Re: Crandall Canyon Mines, C/015/032
C15-003 Midterm Review Task ID# 55011

Attached you will find the application addressing the deficiencies regarding the Midterm review of Crandall Canyon Mine.

Following this letter, you will find the C1 and C2 forms, a summary of deficiencies and detailed actions taken to correct them, and 2 copies of each of the following: edited pages, red line strike out, and maps.

G:\Current Drawings\WRP Maps\Crandall Canyon\2015 Mid-Term Review\1-1 LEASE MAP REV13.dwg, Plate 1-1, 1/11/2016 9:22:00 AM, 1:1

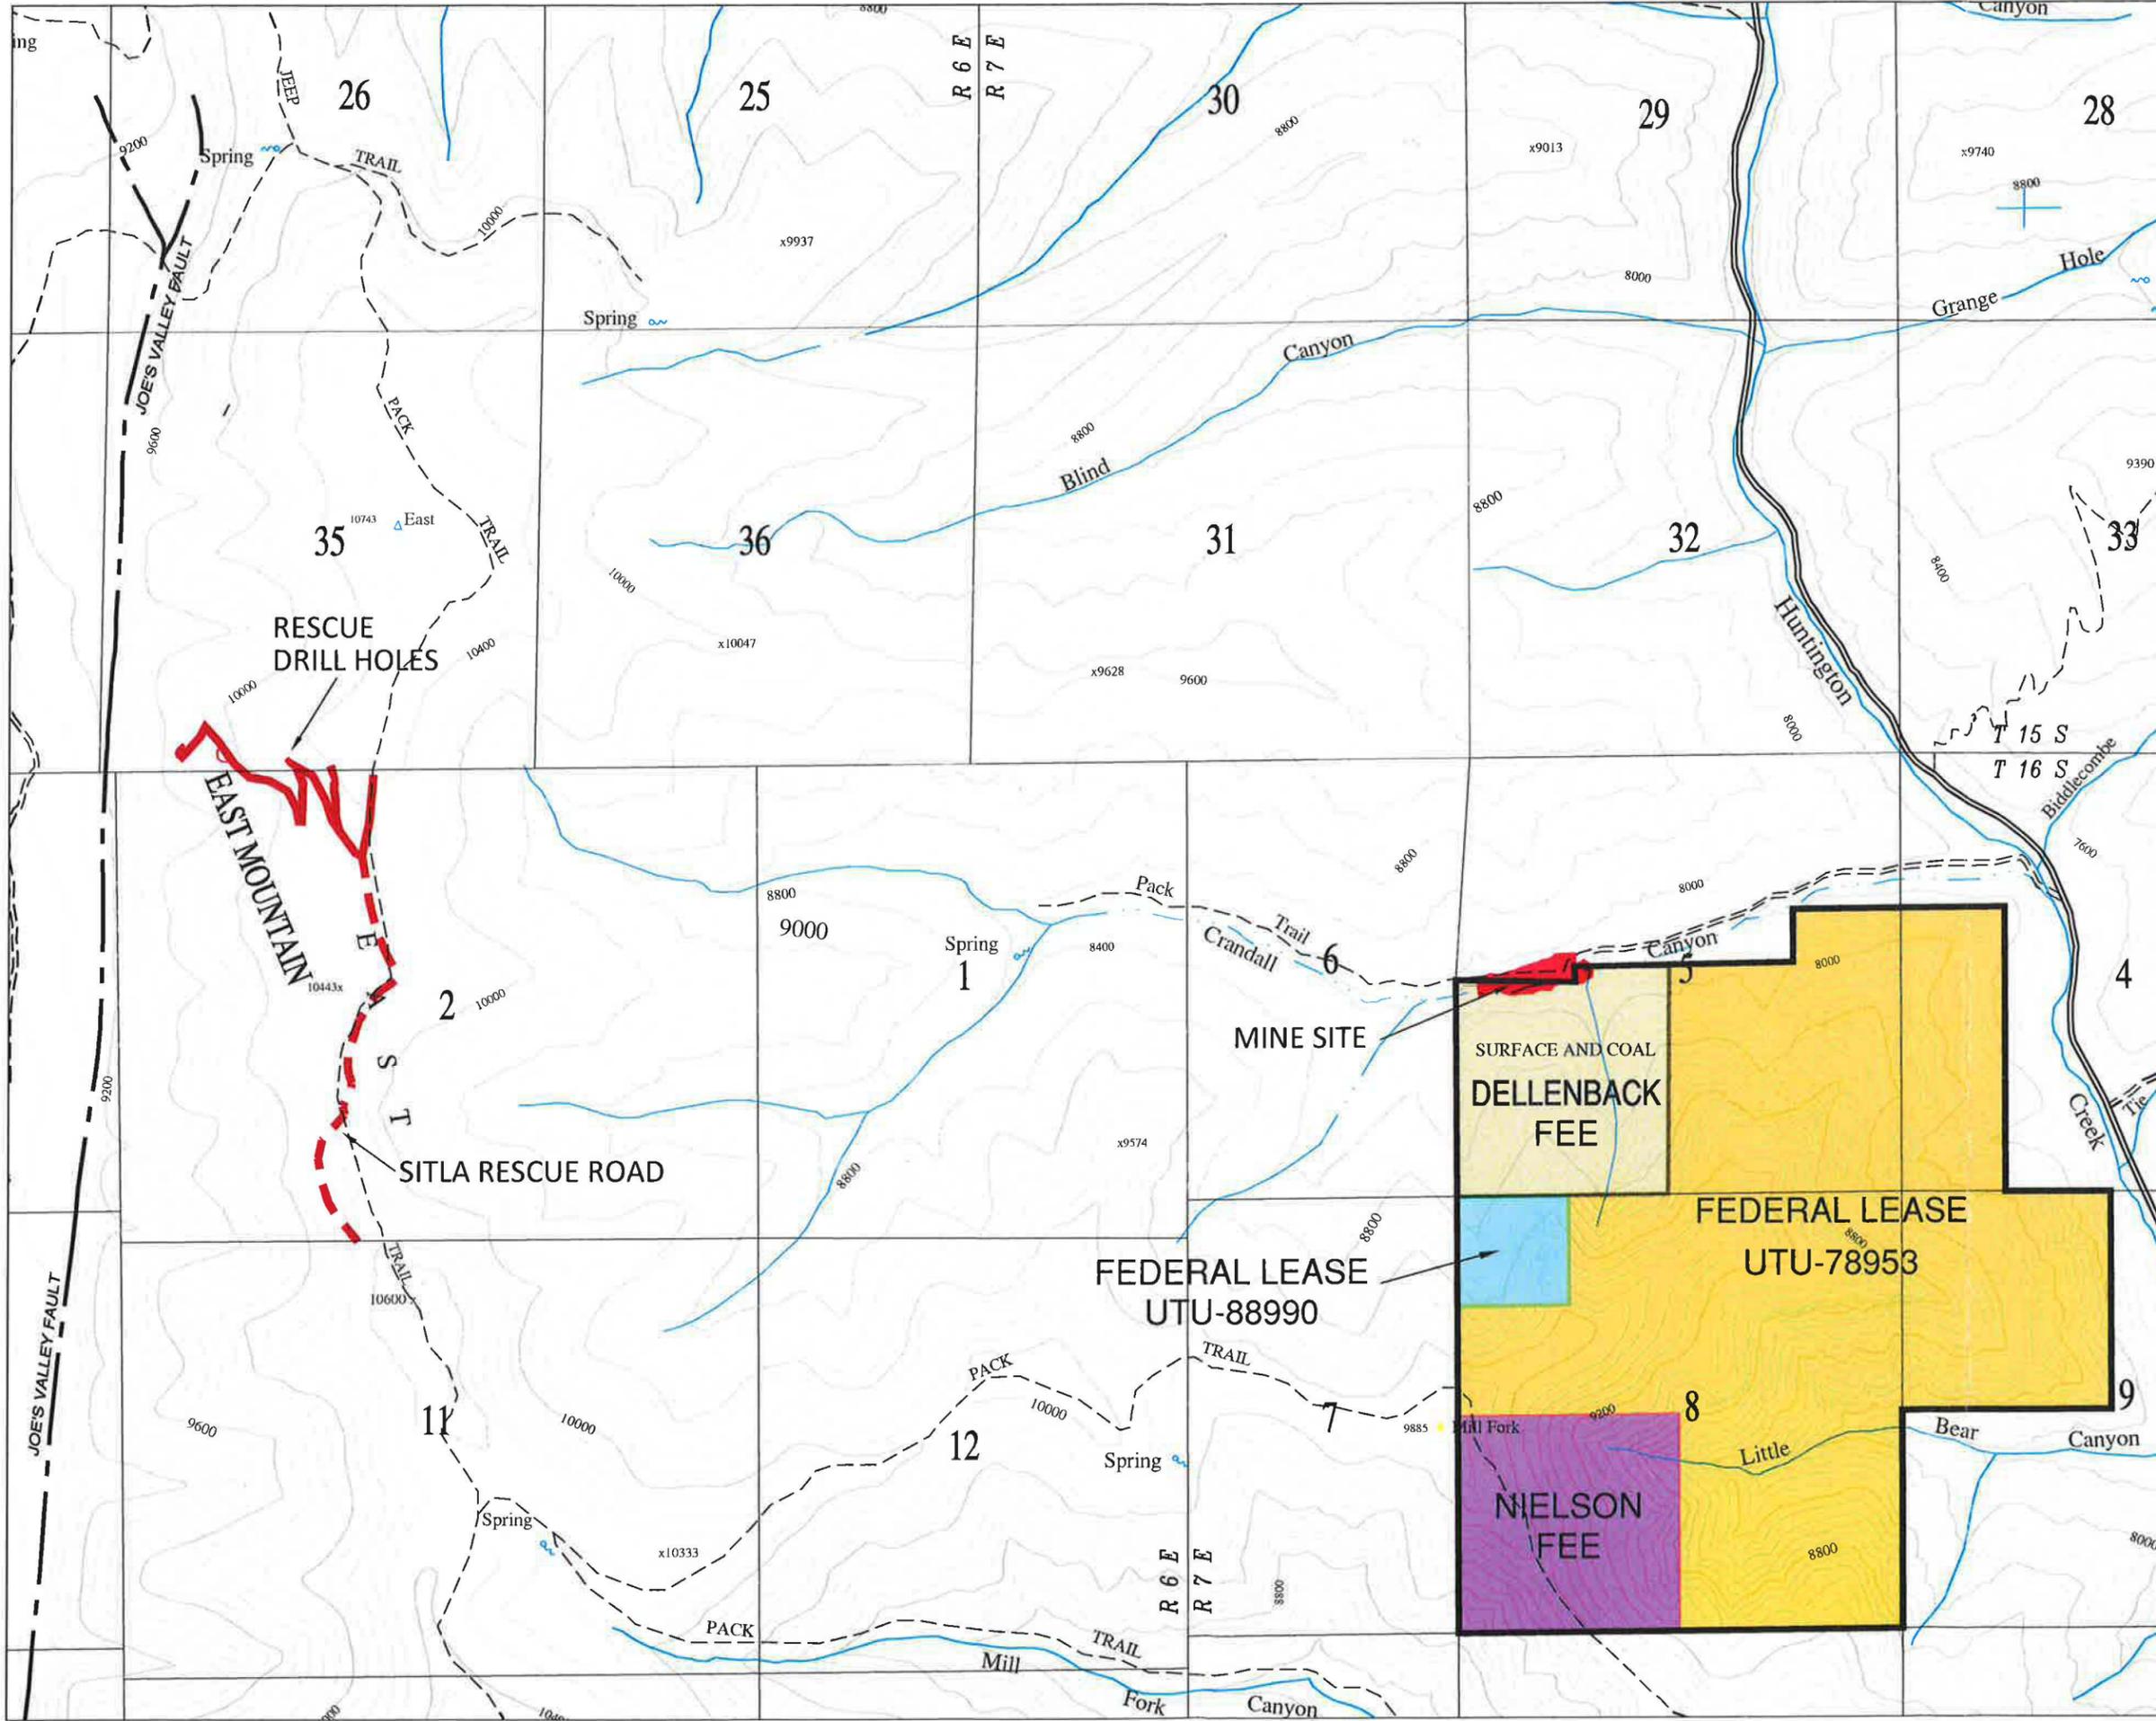
The Current Crandall Canyon Mining and reclamation plan does not meet R645 requirements for right of entry information. The permittee must revise/update the lease information in the MRP . The lease information provided in the Crandall Mining and Reclamation plan needs to be revised to reflect the current leases held by the permittee. Section 114 Right of Entry information, beginning on page 1-5 as well as the first page of Chapter 1 need to be revised/updated. In addition, all maps, figures and plates that depict lease boundaries must be updated.

Section 114 in Chapter 1 as well as page 1 in Chapter 1 has been edited to reflect most current information. All maps, figures and plates have been also been revised.

REV: 8	ACAD: SUBSIDENCE MONITORING R8
DATE: 01-13-16	BY: JDS/PJJ
SCALE: 1" = 2000'	PLATE #: 5-5

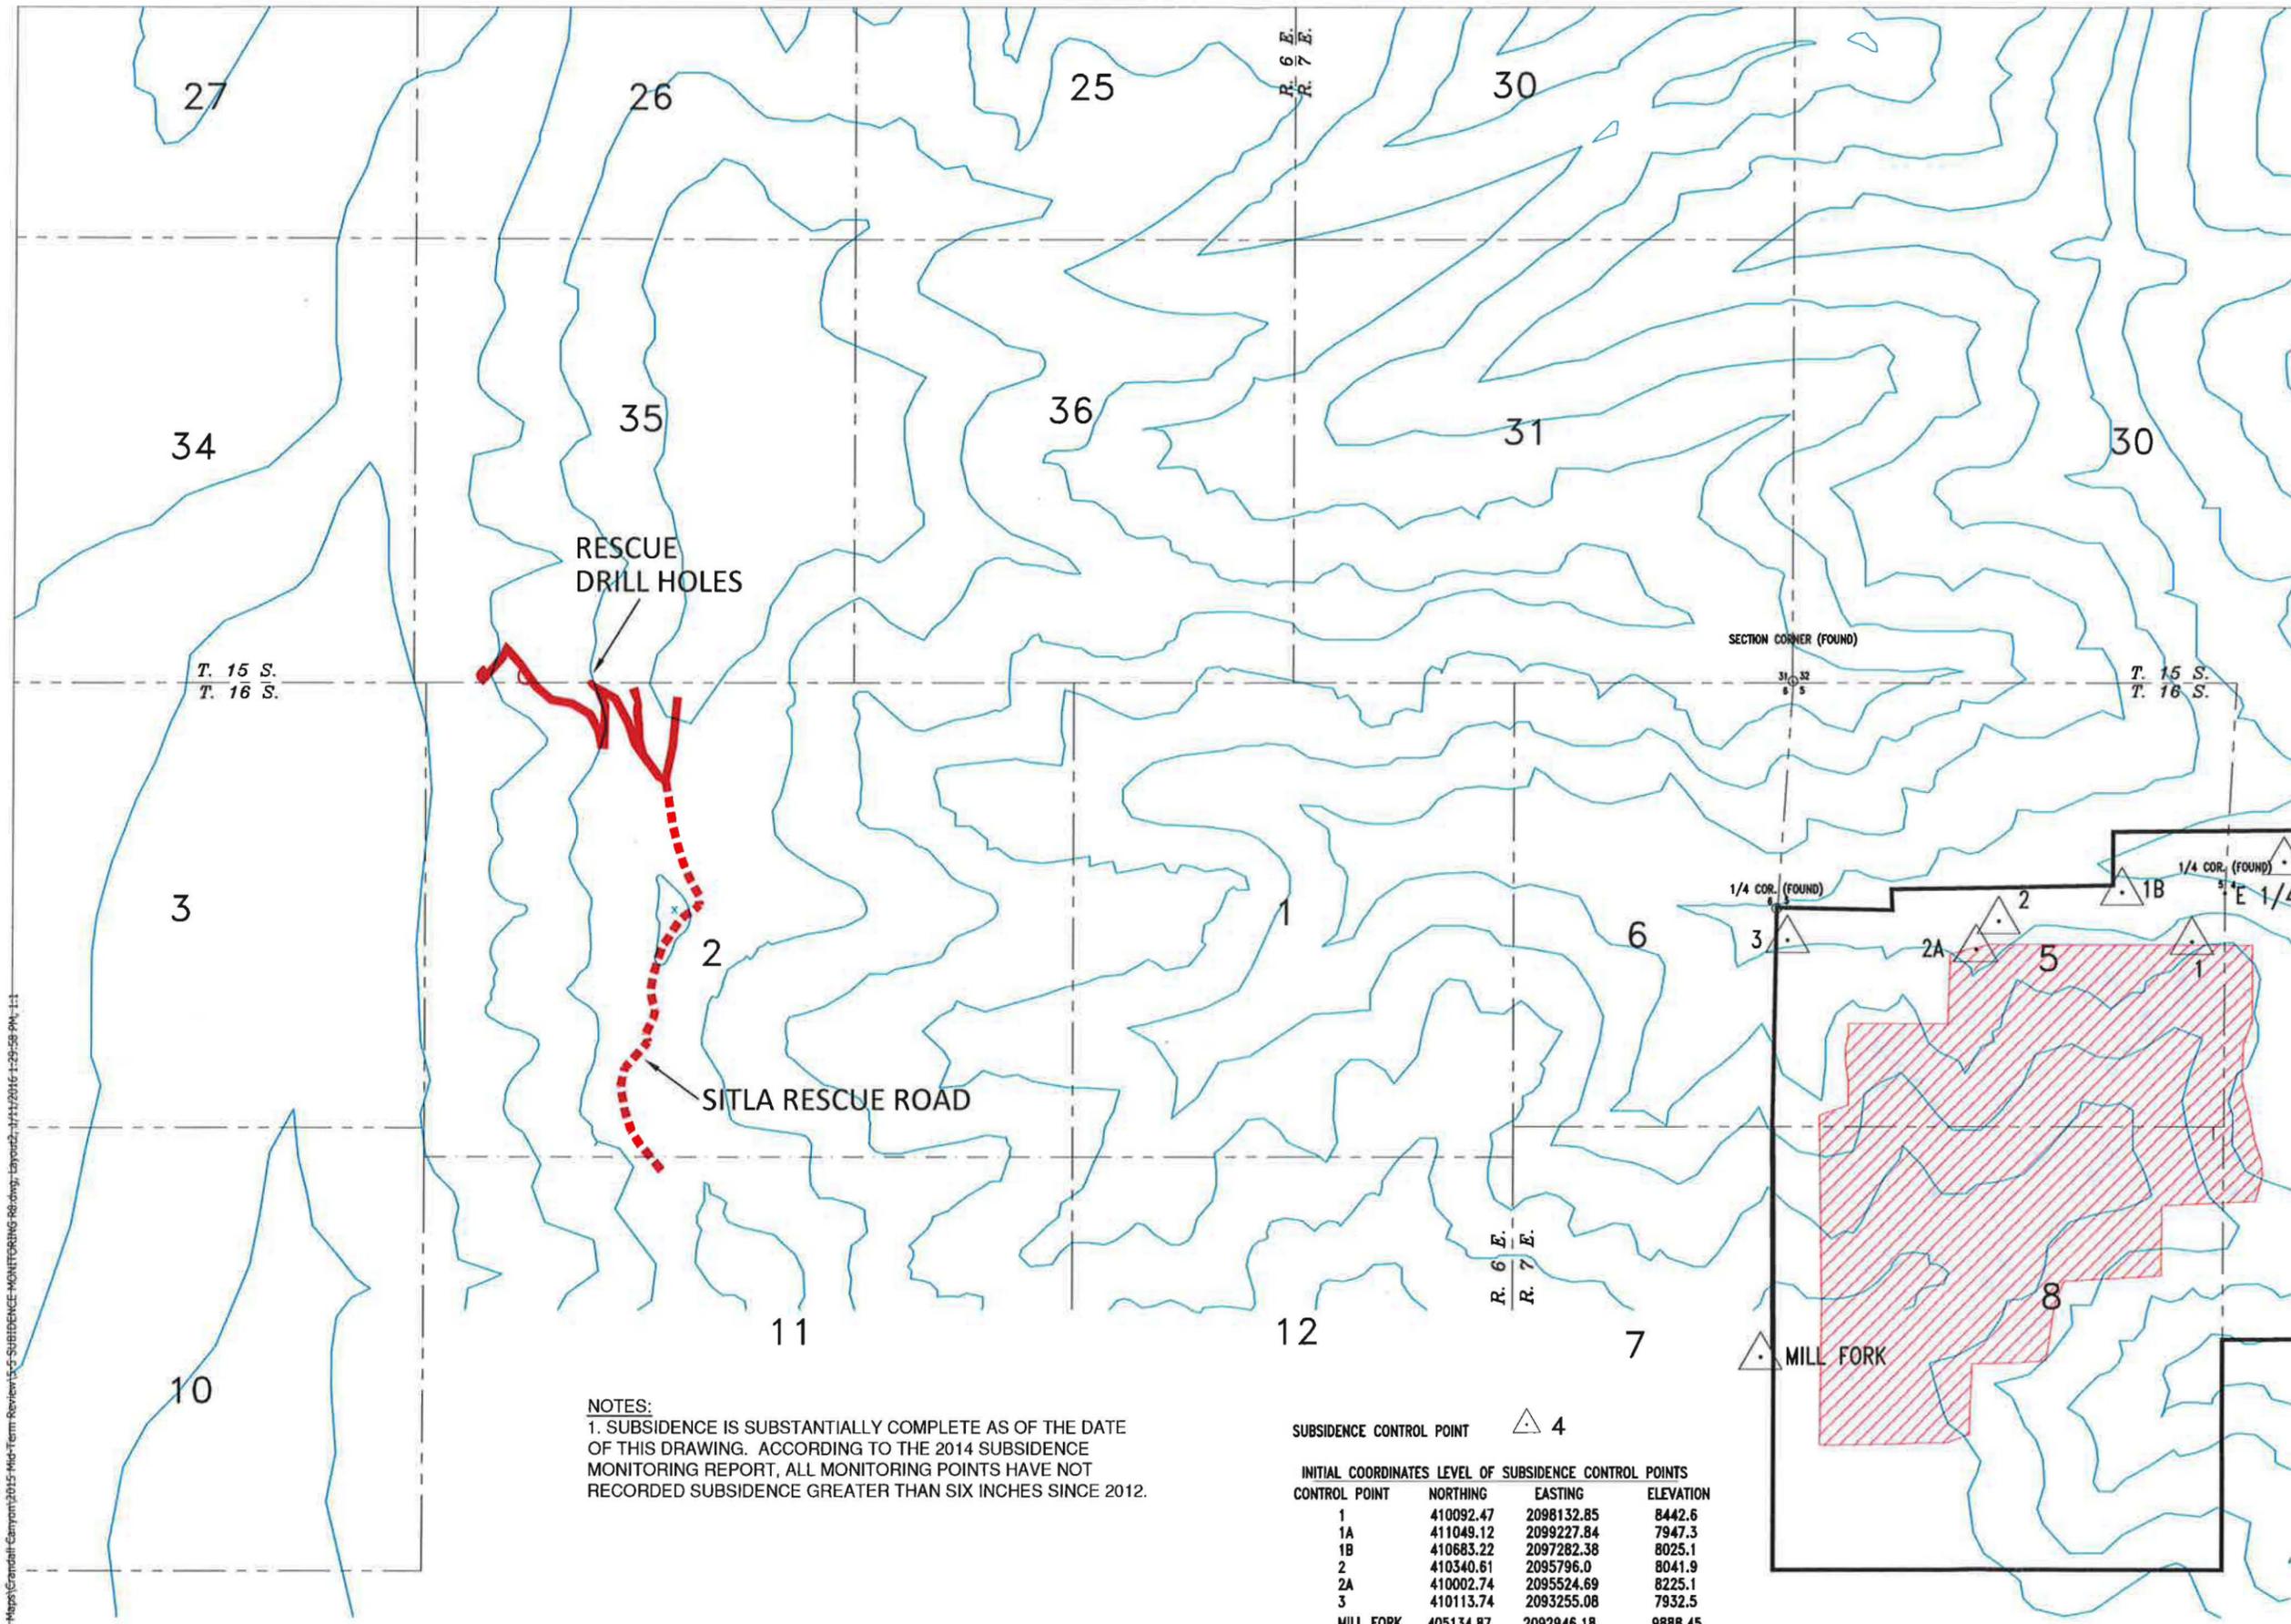
The minimum requirements of R645 are met in the current MRP as the permittee presented a clear subsidence plan for protected are, however, subsidence monitoring requirements have been met as of 2014 and annual subsidence monitoring should be removed from the MRP. Section 5.25.14 of chapter 5 of the MRP states the annual requirement of vertical and horizontal positions of all monitoring points and pins directly over and within the 20 degree angle of draw to the mined area surveyed by aerial photography for that specific year. The subsidence monitoring that subsidence is substantially complete. Plate 5-5 and 5-5(2) detail the coordinates for all subsidence monitoring locations, including monitoring points over areas where the lease has been relinquished. The Permittee has submitted updated annual subsidence information since 2004 for the south Crandall mine and since 2012 for the east mountain reclaimed slide area. As of the 2014 subsidence monitoring report, all monitoring points have not recorded any subsidence greater than six inches since 2012. The permittee should amend the MRP to include demonstration of subsidence is substantially complete, and will no longer be monitored.

Monitoring requirements have been met as of December 2015, and no subsidence over 1 foot has occurred in the last 5 years.. Mining was idled after the 2007 accident, and mining is anticipated to resume after the market improves. Once mining has resumed, subsidence monitoring will resume as well. Maps have been revised.
